## **OPTIONAL SERVICE BULLETIN**

Model DA 40 F

### OPTIONAL SERVICE BULLETIN NO. OSB F4-043 REV. 0

Vertical stabilizer rivet nuts replacement by anchor nuts.

Figure 1. VS-HS fairing removal.

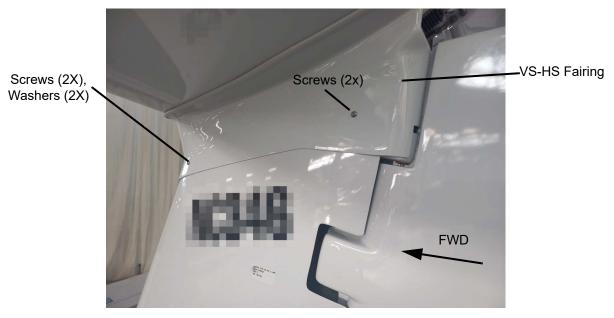
1. Remove the 4 screws and 2 washers which attach the VS-HS fairing. Refer to Figure 1.

Figure 2. Anchor nut installation.

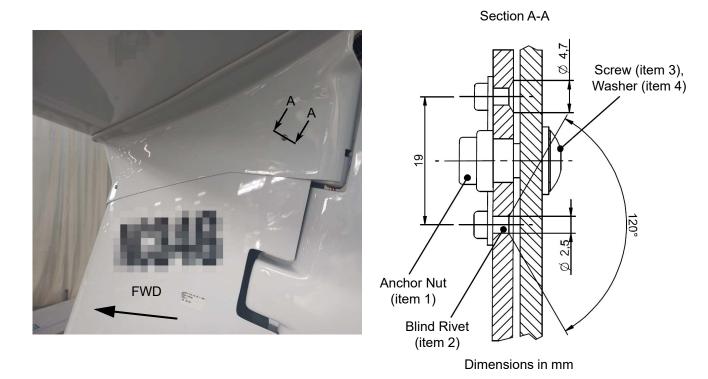
5. To install the 2 anchor nuts (item 1) at the same installation points of the rivet nuts, drill the vertical stabilizer to install the 4 blind rivets (item 2). Refer to Figure 2.

Figure 3. Anchor nuts installed on the vertical stabilizer

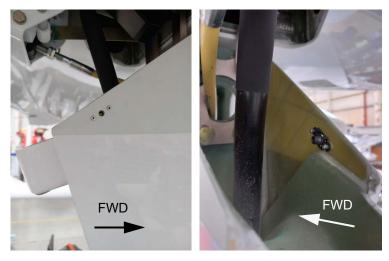
6. Install the 4 blind rivets (item 2) to attach the 2 anchor nuts (item 1) to the vertical stabilizer. Refer to Figures 2 and 3.

Figure 4. VS-HS fairing installation.

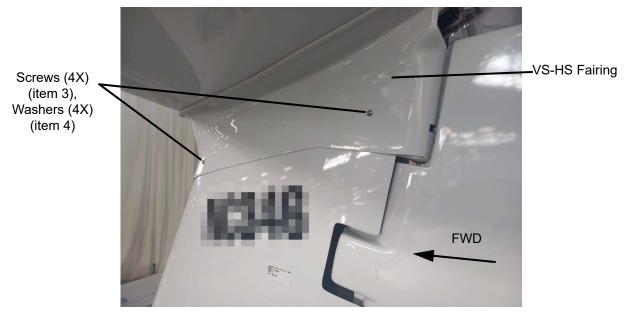
- 7. Put the VS-HS fairing in the installation position. Refer to Figure 4.
- 8. Install the 4 screws (item 3) and the 4 washers (item 4). Refer to Figure 4.
